Arrowhead-Stone Lake-Gardner Park 345 kV Line Concerns

September 2, 2005

3000 MW ATC Import Arrowhead 345 kV PV Curves under Intact and King-Eau Claire-Arpin Outage Conditions

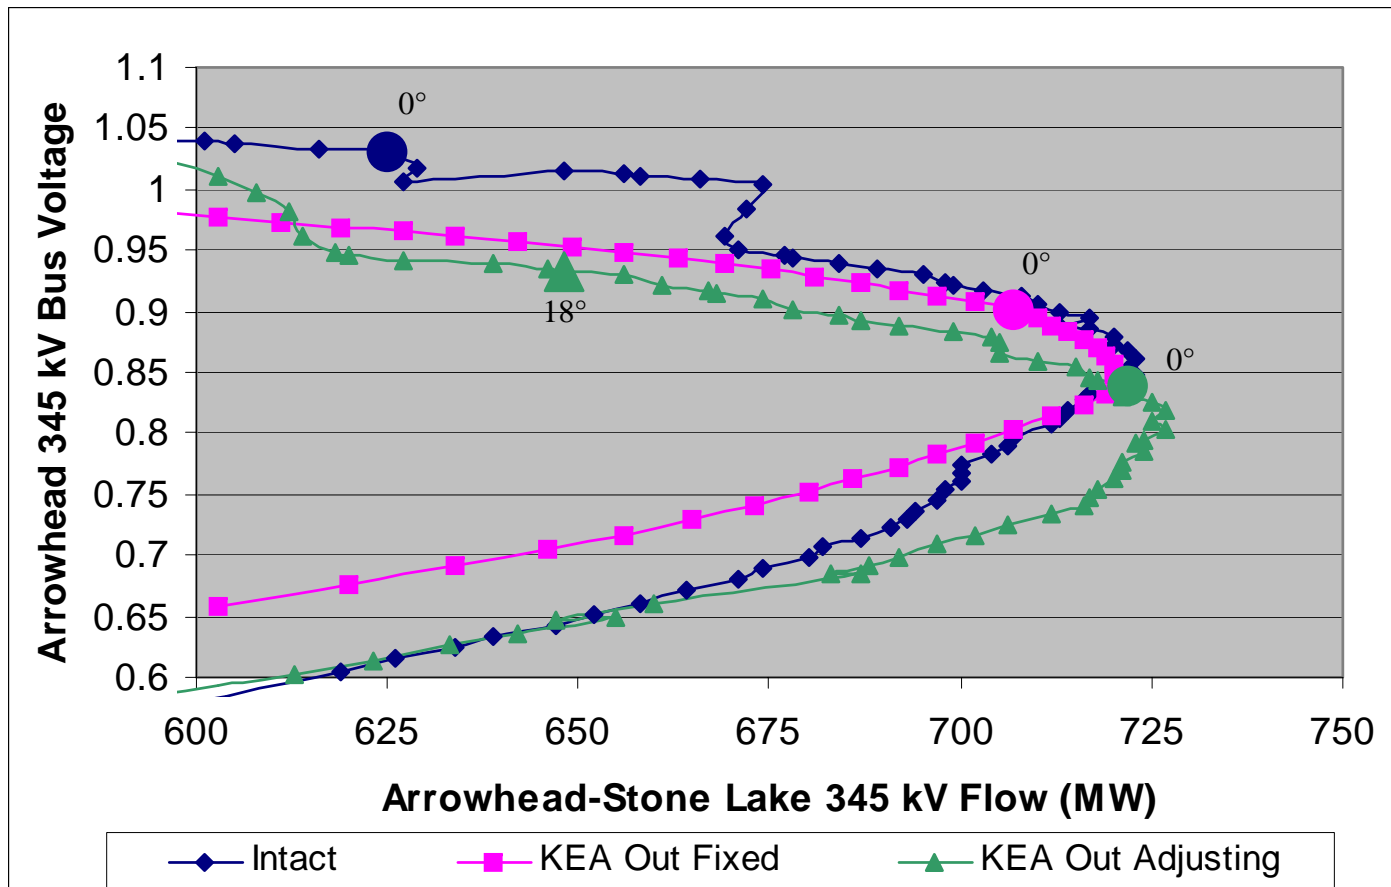
Concern: Stability Limit Exceeded During King-Eau Claire-Arpin Outage

- Under Severe Conditions Simulated Voltage Stability Limit NOT Exceeded with KEA Out (9/24/04 Voltage Stability Analysis Report)
 - An acceptable (10%) margin exists under intact system conditions and a 0° PST angle
 - KEA outage causes line flow to approach limit
 - PST Operation Returns Line Flow to an Acceptable margin following KEA outage
 - Line Flow is reduced less than 10% by PST
